# Access Compliance Report

## Public Rights-of-Way

Intersection ID: 3003	Main Street: GOLDEN_POND_DR	Cross Street: WOODFIRE_RD	Location: SE
ADA ID: 364A4E855631	Ramp Type: Perp	Initial Pass/Fail: Fail	Overall Compliance: No
Codes/Mitigation Info/Possible Solution			Severity Score: 50
			Field Measurements/Component Compliance

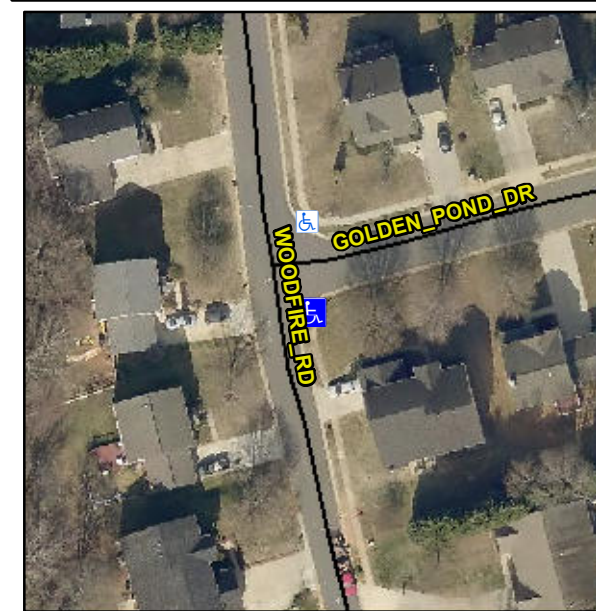
**R304.2.2, R304.5.3**

Compliance	Description	Data	Compliance	Description	Data
N/A	Ramp Length (in)	47.0	No	Ramp Slope (%)	15.1
Yes	Ramp Width (in)	48.0	No	Ramp XSlope (%)	12.1
N/A	Flare Type LT	N/A	N/A	Flare Type RT	N/A
N/A	Flare Slope LT (%)	N/A	N/A	Flare Slope RT (%)	N/A
N/A	Flare Traversable LT?	N/A	N/A	Flare Traversable RT?	N/A
N/A	Landing Length (in)	N/A	N/A	DWS Provided?	N/A
N/A	Landing Width (in)	N/A	N/A	DWS Contrast?	N/A
N/A	Landing Slope (%)	N/A	N/A	DWS Length (in)	N/A
N/A	Landing X Slope (%)	N/A	N/A	DWS Full Width?	N/A
N/A	Landing Curb? (Y/N)	N/A	N/A	DWS Offset (in)	N/A
N/A	Shared Landing?	N/A			
N/A	Gutter Ponding?	N/A	N/A	Gutter Slope (%)	N/A
N/A	Gutter Lip Ht (in)	N/A	N/A	Gutter X Slope (%)	N/A
N/A	Painted X Walk1?	No	N/A	Painted X Walk2?	N/A
	X Walk 1 Direction	To N		X Walk 2 Direction	N/A
N/A	X Walk 1 Width (in)	N/A	N/A	X Walk 2 Width (in)	N/A
	X Walk 1 Slope (%)	4.6		X Walk 2 Slope (%)	N/A
	X Walk 1 X Slope (%)	6.1		X Walk 2 X Slope (%)	N/A

**Remove & Replace Entire Ramp.**
